■2RZ-E ENGINE

Exhaust System

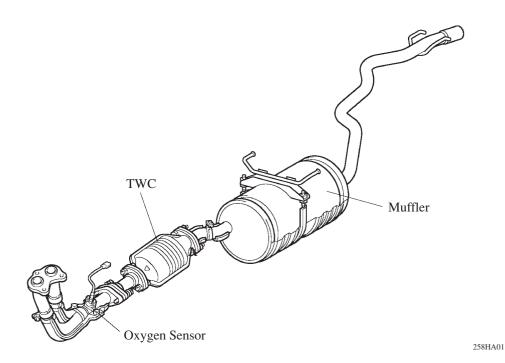
- A ceramic type TWC has been adopted.
- One oxygen sensor has been newly provided in front of the TWC in order to improve the exhaust reduction performance of the TWC through feedback control to the engine ECU.
